Our Ref: 2004_IPL69

Application Reference: A006876448
Property Address: 260 Musgrave Road, Coopers Plains
Subject: Traffic Statement – Response to Further Issues

Item 1 – Traffic

1 SITE PLAN - PROPOSED

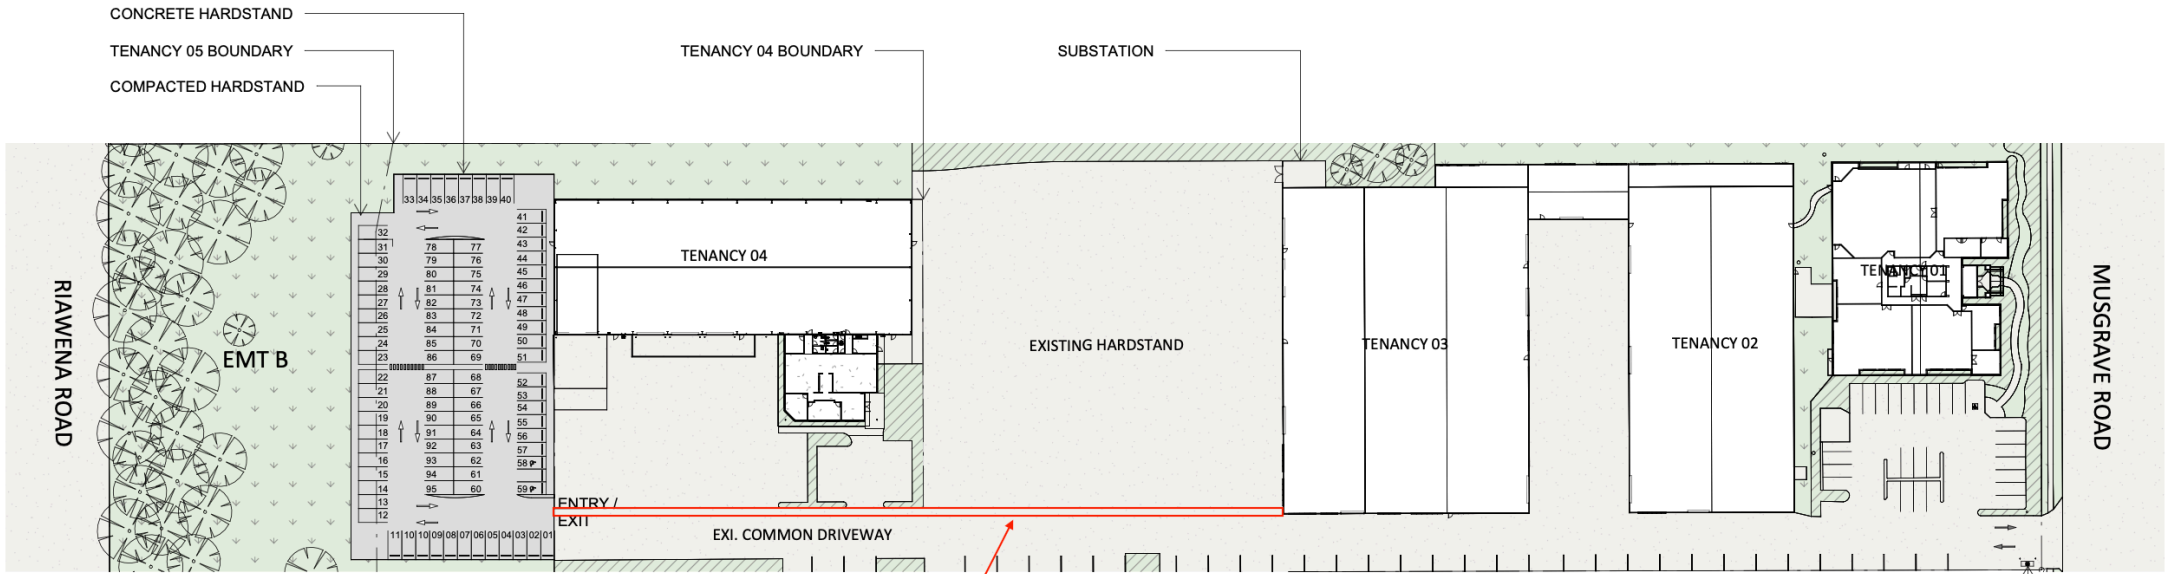
- a) Physical end of parking module protection is required against circulation areas in accordance with AS2890.1:2004. This ensures the safety of vehicle occupants accessing vehicles parked next to circulation aisles.***
- b) Submit amended plans to demonstrate an efficient and safe pedestrian path between the proposed new parking and buildings. Specifically, marking for the existing common driveway is required.***

The amended plans included as **Attachment 1** show, conceptually, the provision of end aisle protection within the northern parking module. The detail shown is indicative only and can reasonably be conditioned by Council to accord with Figure J of the Transport, Access, Parking and Servicing Planning Scheme Policy.

The amended plans included as **Attachment 1** show, conceptually, a delineated pedestrian pathway through the existing common driveway linking the northern parking area with the southern tenancy.

The detail shown is indicative only. In our opinion, the pedestrian connection can readily be detailed to provide a clear and legible pedestrian route between the additional parking area and the existing development and can reasonably be conditioned by Council.

Existing common driveway to be modified to incorporate new line marking for a pedestrian prioritised pathway
